PIC16(L)F1782/1783 Family Silicon Errata and Data Sheet Clarification

The PIC16(L)F1782/1783 family devices that you have received conform functionally to the current Device Data Sheet (DS41579B), except for the anomalies described in this document.

TABLE 2: SILICON ISSUE SUMMARY

FIGURE 1: ADC 12-BIT MODE, SINGLE-ENDED INL, $V_{DD} = 3.0V$, $T_{AD} = 4 \mu s$, $25^{\circ}C$, TYPICAL MEASURED VALUES

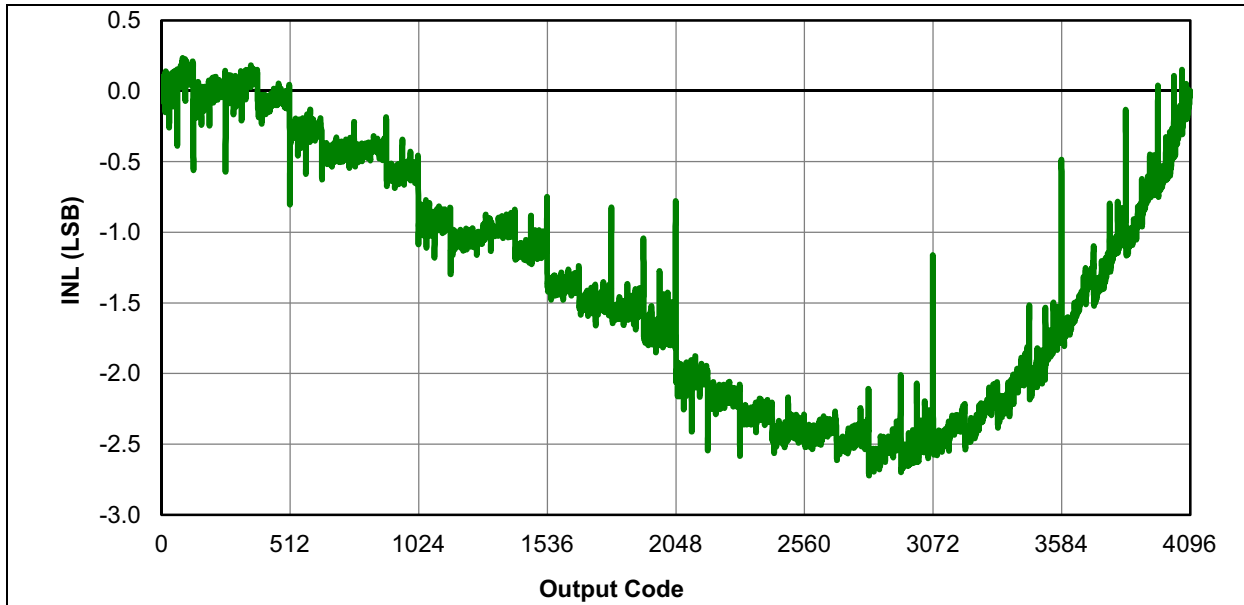
1.3 ADC INL (12-bit mode)

The ADC linearity is ± 4 LSB for the 12-bit mode. Below are typical INL graphs in 12-bit mode (See [Figure 1](#) and [Figure 2](#)).

None.

**FIGURE 3: OP AMP TYPICAL OFFSET VOLTAGE AT 25°C,
HIGH GBWP MODE (OPAxSP = 1), V_{DD} = 3.6V, 0V ≤ CMV ≤ 5.5V**

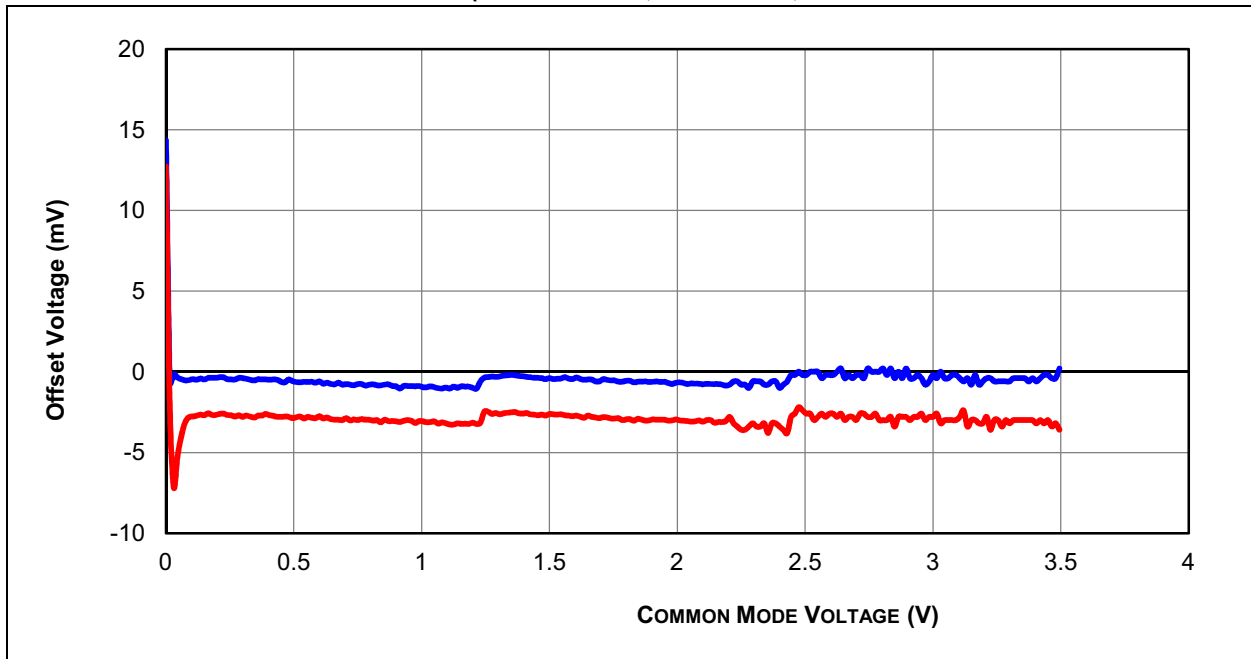
2.1 Offset at Low Common Mode

The op amp offset at Common mode input voltages below 200 mV increases with respect to temperature. Below are typical graphs showing the increase in offset (See [Figure 3](#), [Figure 4](#) and [Figure 5](#)).

None.

FIGURE 6: COMPARATOR INPUT OFFSET, TYPICAL MEASURED VALUES, NORMAL SPEED MODE (CxSP = 1), $V_{DD} = 5.5V$, PIC16F1782/1783 ONLY

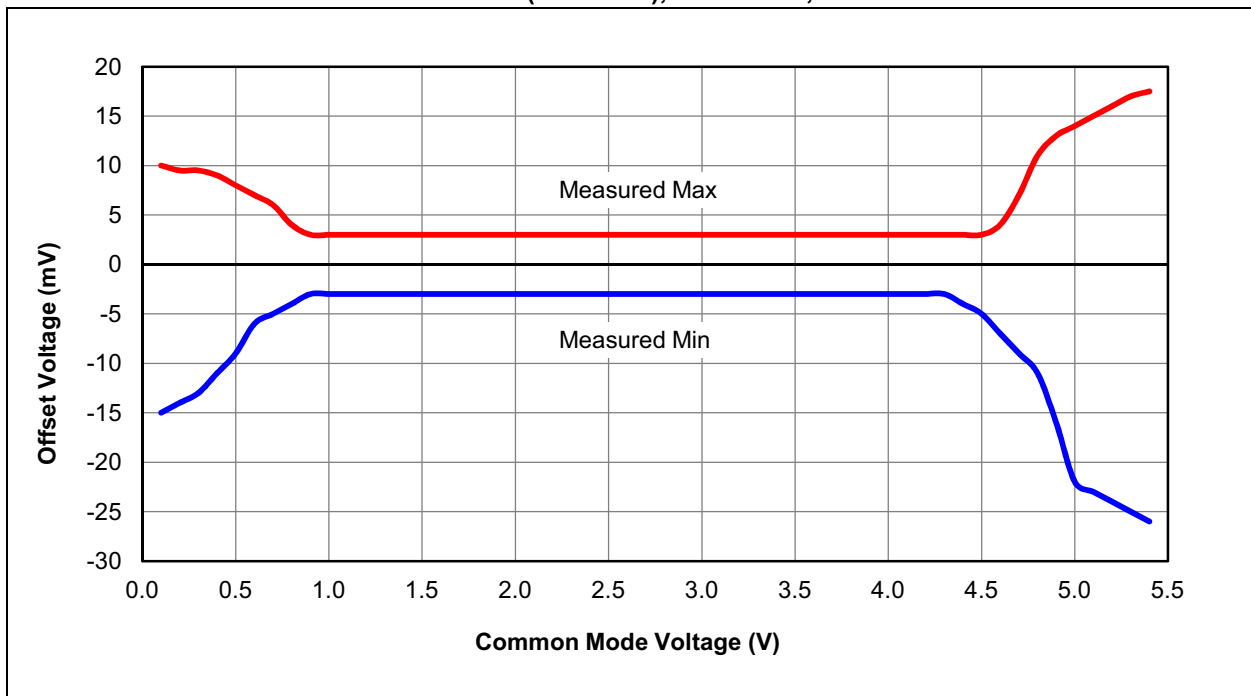
3.2 Typical Offset Performance

CMRR performance for the range of $V_{SS} + 1V$ to $V_{DD} - 1V$ is better than specified in the data sheet.

See [Figure 6](#) and [Figure 7](#).
